This Service Letter reidentified as
Service Bulletin M 20-115
per Service Instruction M20-15.

SUBJECT: Inspection and Repair of Wheel Well Plate to
Wing Skin Attachment

MODELS AFFECTED: M20C, Serials 2506 thru 2622
M20E, Serials 101 thru 200

FIG 1
VIEW LOOKING DOWN ON AIRPLANE

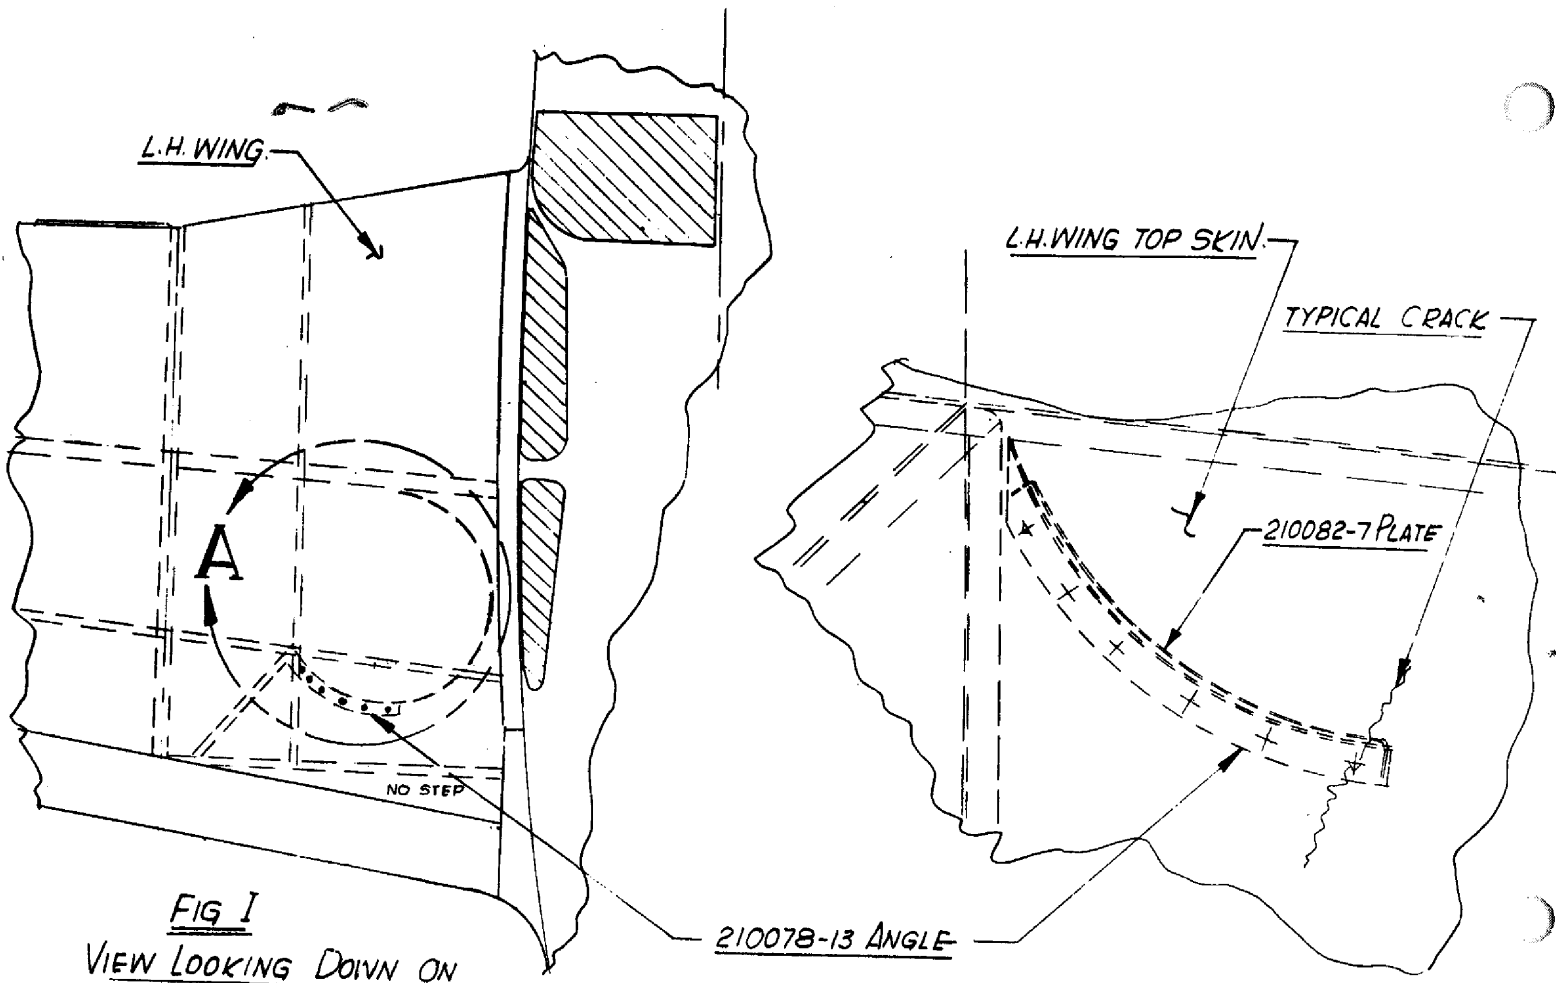
There have been occurrences of fatigue cracks developing in the top left wing skin, above the main gear wheel well at the attach of Part No. 210078-13 angle. This service letter describes the inspection for and repair of such cracks if they develop.

1. At each 100 hour inspection, check the area described in Figure 1 for cracks from the last rivet attaching the wheel well plate to the top wing skin.
2. If cracks are found, remove 210082-7 plate and 210078-13 attach angle shown in Figure 1.
3. Cut out circular hole around crack, with edge of hole $\frac{1}{4}$ " minimum beyond the crack. Cut and locate a doubler per Figure 2 and rivet it and 210078-13 angle to the wing skin. Cut and install a filler plate to the attach angle and the doubler plate as shown.
4. Replace 210082-7 plate with $\frac{1}{8}$ " dia. rivets (may be blind rivets).
5. Repair may be smoothed over with any standard aerodynamic smoother (or body filler) before painting.
6. After repair has been accomplished, further inspection as described in Step 1 will not be necessary.
